Appl. No. 10/771,800
Amdt. dated 3 February 2006
Reply to Office action of January 4, 2006

ANNOTATED SHEET SHOWING CHANGES

Title: Trencher Unit, Docket 3120W

FIG. 2

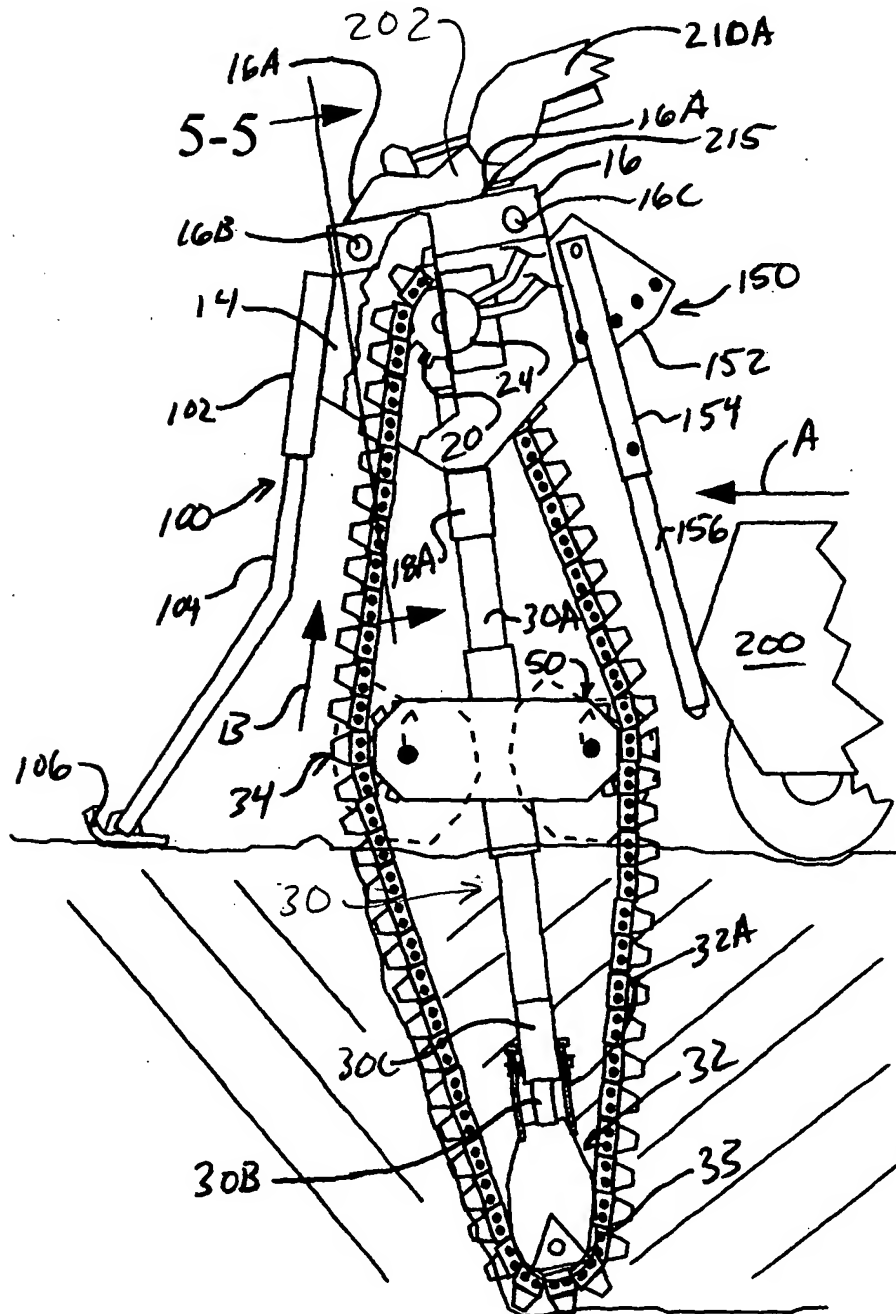
The attached sheets of drawings include changes to Figs. 2, 3, 3E, 3F, 5C, and 6A - 7C. These sheets, which include Figs. 2, 3, 3E, 3F, 5C, and 6A - 7C replace the original sheets including Figs. 2, 3, 3E, 3F, 5C, and 6A - 7C. In Fig. 2 previously omitted reference numerals 202 and 30 have been added. In Fig. 3 previously omitted reference numeral 30 has been added. In Fig. 3E previously omitted reference numeral 50 has been added. In Fig. 5C previously omitted reference numeral 14 has been added. In Figs. 6A, 6B, 7A, 7B and 7C previously omitted reference numerals 30 and 34 have been added. In Fig. 6C previously omitted reference numerals 30, 34 and 50 have been added.
